PERMIT

SEWAGE DISPOSAL SYSTEM

MARYLAND STATE DEPARTMENT OF HEALTH*

SUBDIVISION _____ ROAD 6547 Cedar Lane LOT _____

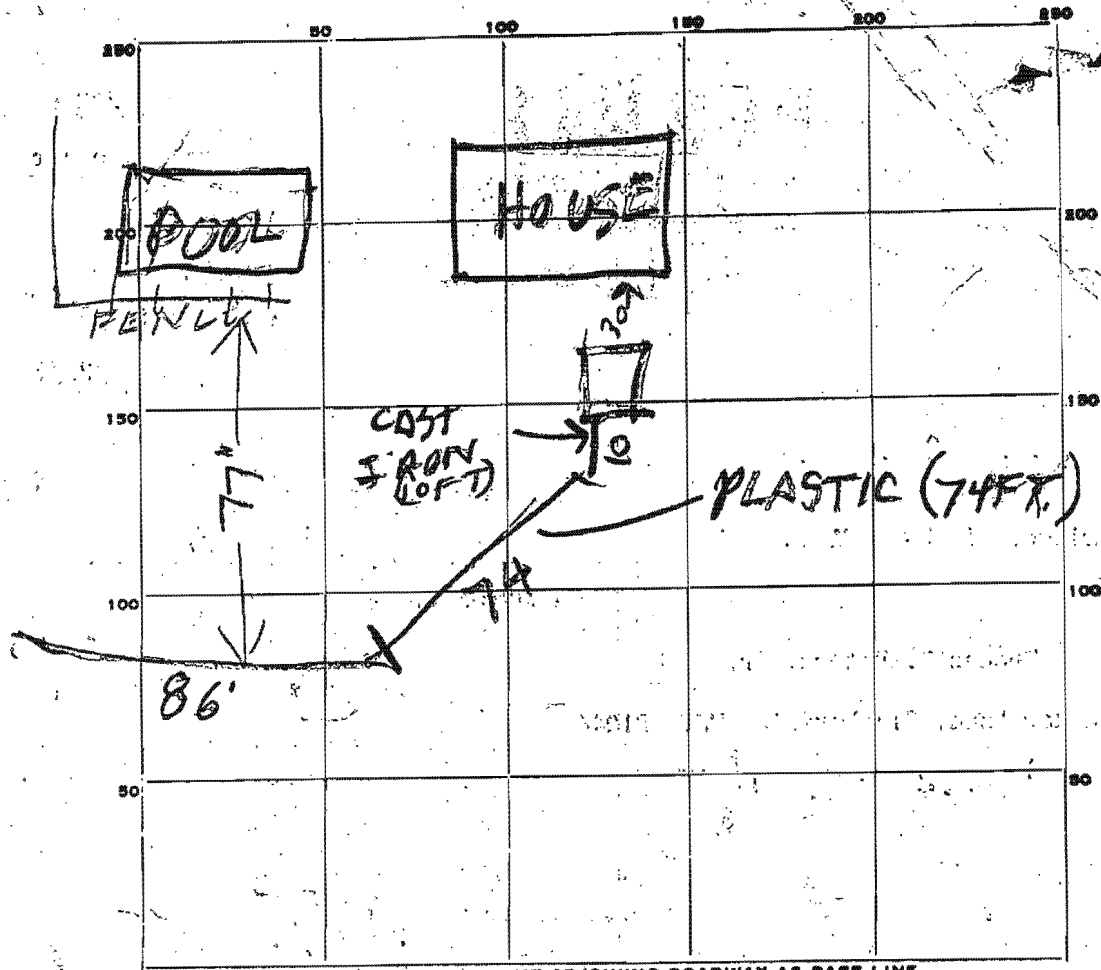
LOCATE DISPOSAL AREA **TRENCH** FT. FROM _____ LOT LINE AND _____ FT. FROM _____ LOT LINE AS SEEN WHEN

FACING LOT FROM **IN AREA SHOWN ON ATTACHED DRAWING**

REPAIR - Call for an appointment when ground is opened up and Sanitarian will

recommend repair system. **OK TO USE PLASTIC**

PIPE TANK TO TRENCH PER O.M.
OK for metal tank

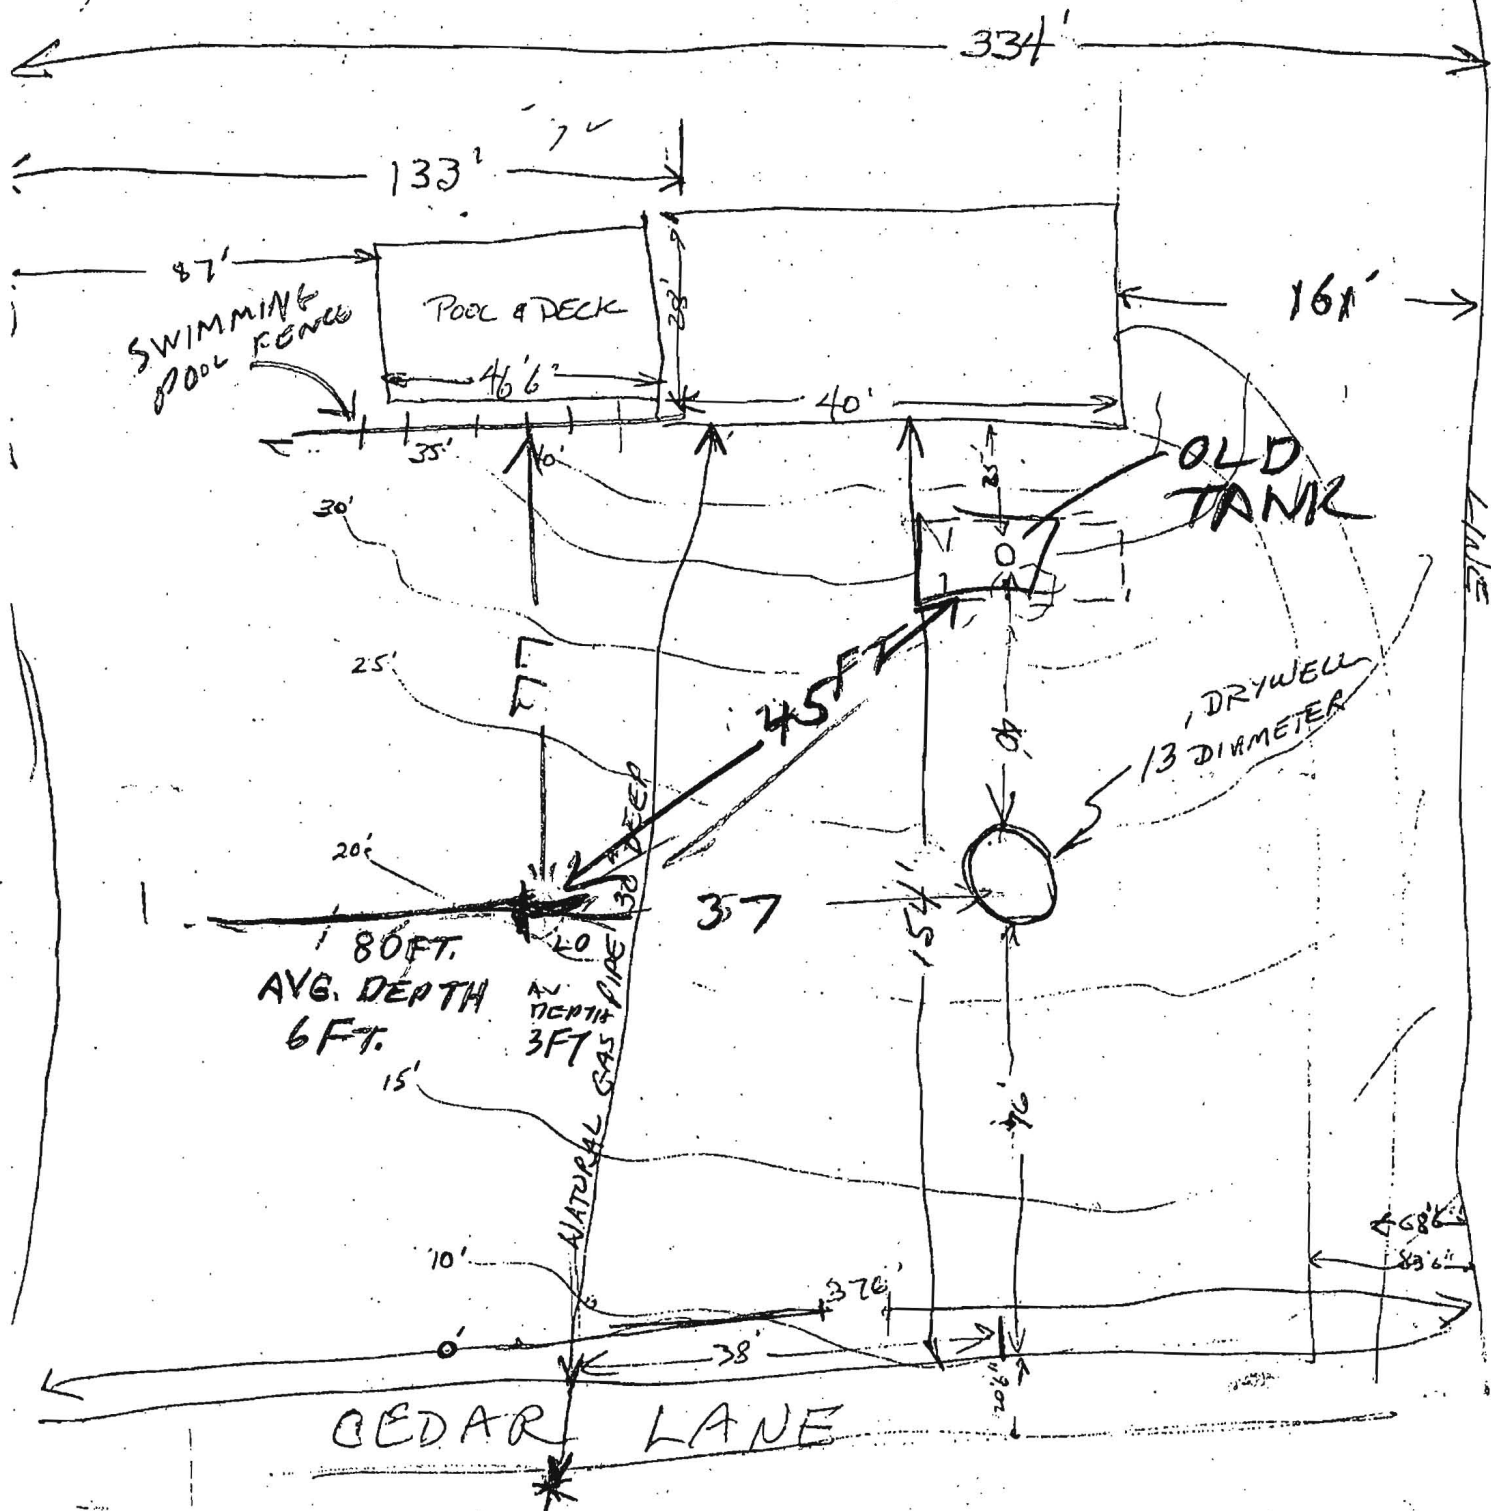
REMARKS 6/6/79 AM DITCH DUG 80 FT LONG
WITH AV DEPTH OF 6 FT & 20 FT LONG WITH
AV DEPTH OF 3 FT SOIL SANDY BUT
UNEVEN ROCK BOTTOM RU 6/6/79 PM
STONE ADDED TO DITCH OK TO COVER DITCH.

BUT NEW TANK NEEDED. CALL FOR INSPECTION OF
TANK & SEWER WORK

DATE SYSTEM APPROVED 6/7/79 INSPECTOR Raymond Hodge
